COMMITTEE OF THE WHOLE MARCH 7, 2005

SITE DEVELOPMENT FILE DA.04.070
MIELE LIMITED

THAT Site Development File DA.04.070 (Miele Limited) BE APPROVED, for a two-storey office building, as shown on Attachment #2, subject to the following conditions:

Site Plan

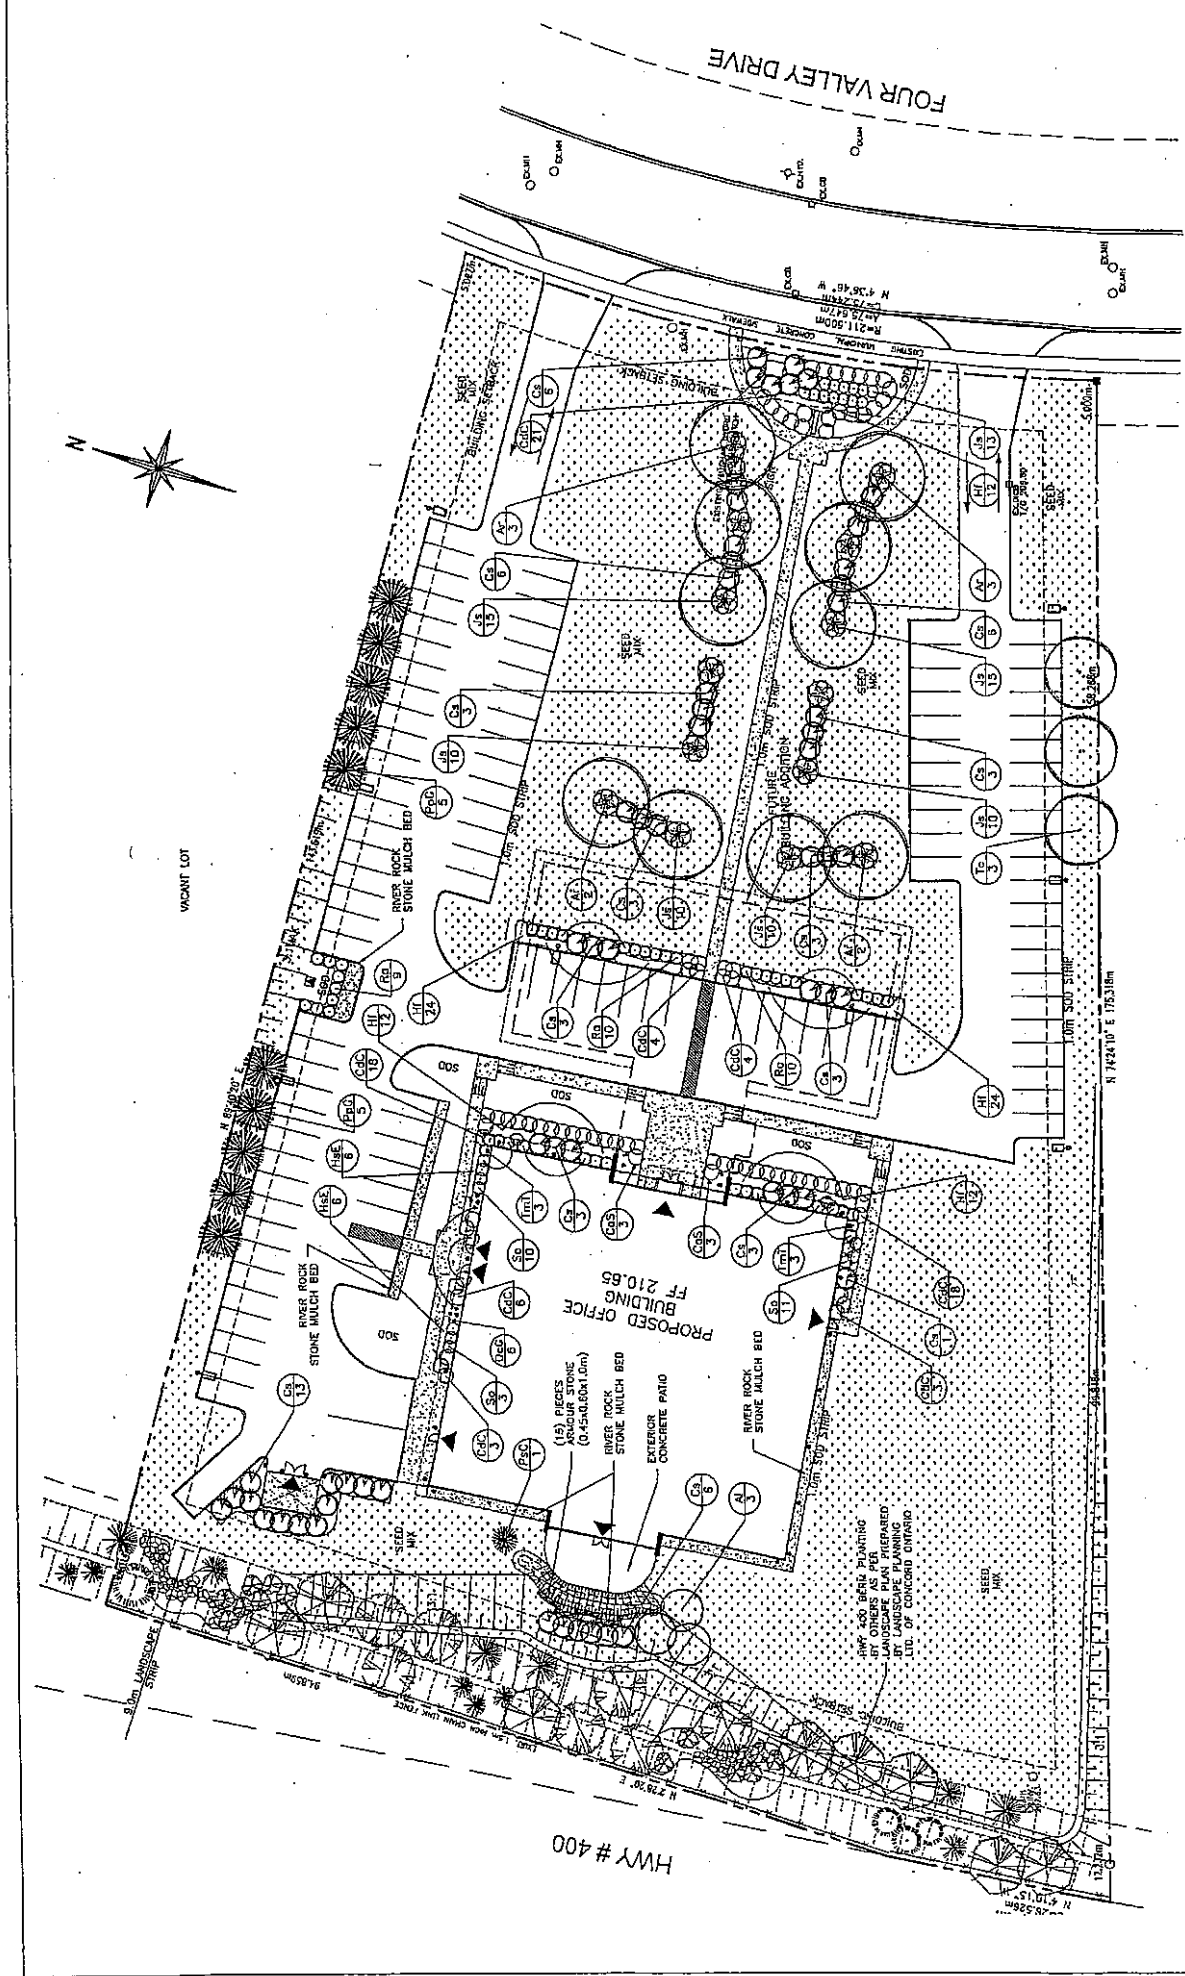
The site plan (Attachment #2) shows a square-shaped, two-storey office building with the main entrance facing Four Valley Drive. The building is setback approximately 95m from Four Valley Drive, with a future addition (Phase 2) contemplated in front (east) of the building. Two driveways are proposed onto Four Valley Drive with parking areas provided to the east and north of the building. An attractively designed detached/roofed structure to contain refuse materials and two loading spaces are proposed north of the building. A pedestrian walkway is shown along the perimeter of the building to provide a connection between each of the building entrances, together with a central walkway between the main entrance and Four Valley Drive.

The proposed development meets the minimum parking requirement of By-law 1-88, with a surplus of 1 space. As a condition of site plan approval, parking access and on-site vehicular circulation will be approved to the satisfaction of the Engineering Department.

North & South Elevations

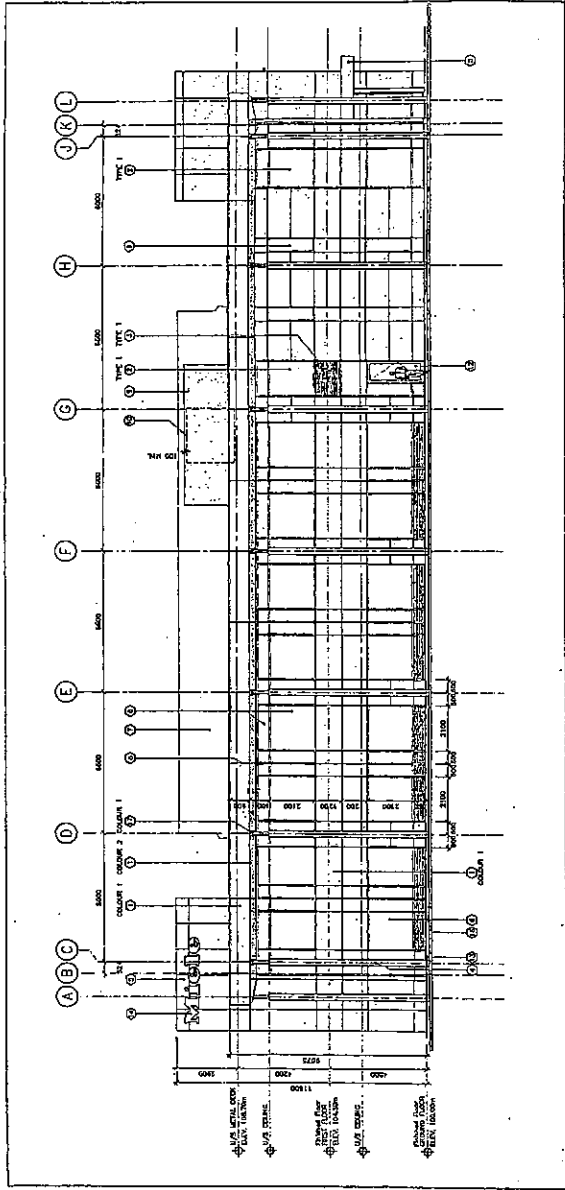
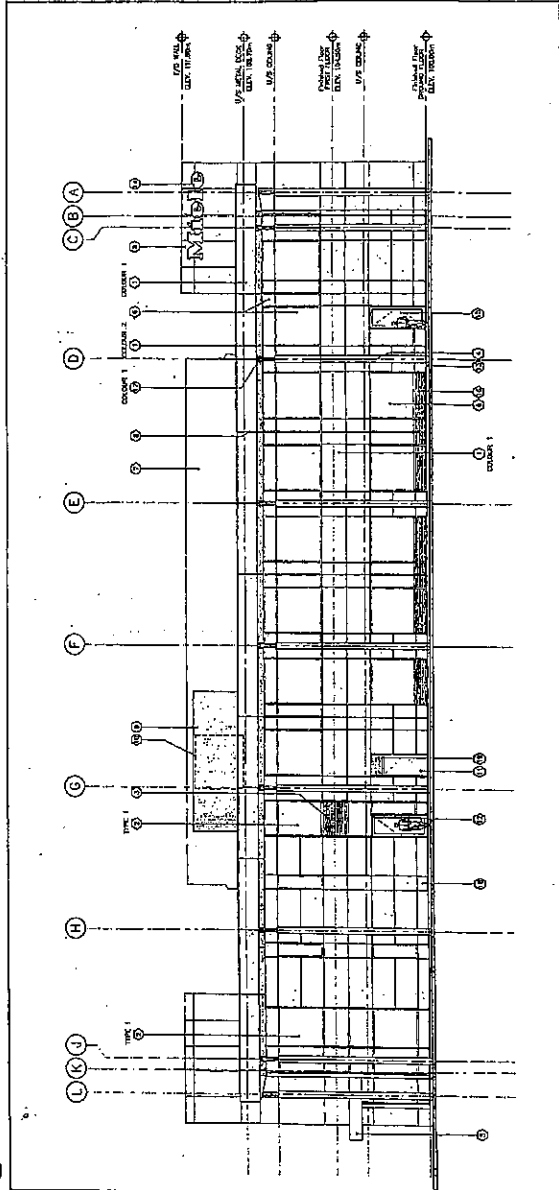
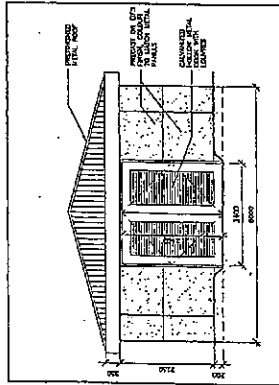
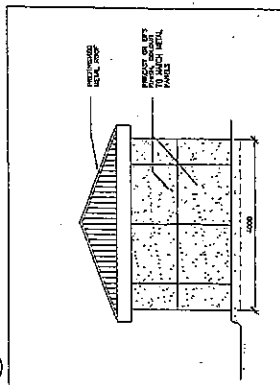
The proposed building elevations are shown on Attachments #4 and #5. The square-shaped office building is two-storeys high with the main entrance and covered canopy facing Four Valley Drive. Secondary entrances are proposed on all other elevations, including the west elevation facing Highway #400, which allows access to a patio. There is considerable amount of glazing on all elevations, together with silver-grey aluminium panels and red composite panel "fin-walls" above the building entrances on the east and west elevations. A skylight system is proposed on the roof, together with metal siding screens to hide two mechanical units. Signage identifying the corporate "Miele" name in white letters is proposed on the upper portion of the "fin wall" visible to Highway #400, and above the main entrance facing Four Valley Drive. The attractively designed refuse structure shown on Attachment #4, measures 4m x 6m and consists of precast panels, metal double-doors with louvres on the east façade, and a pitched metal roof.

Staff are satisfied with the elevations for both structures. As a condition of site plan approval, the final building elevations must be approved to the satisfaction of the Development Planning Department.
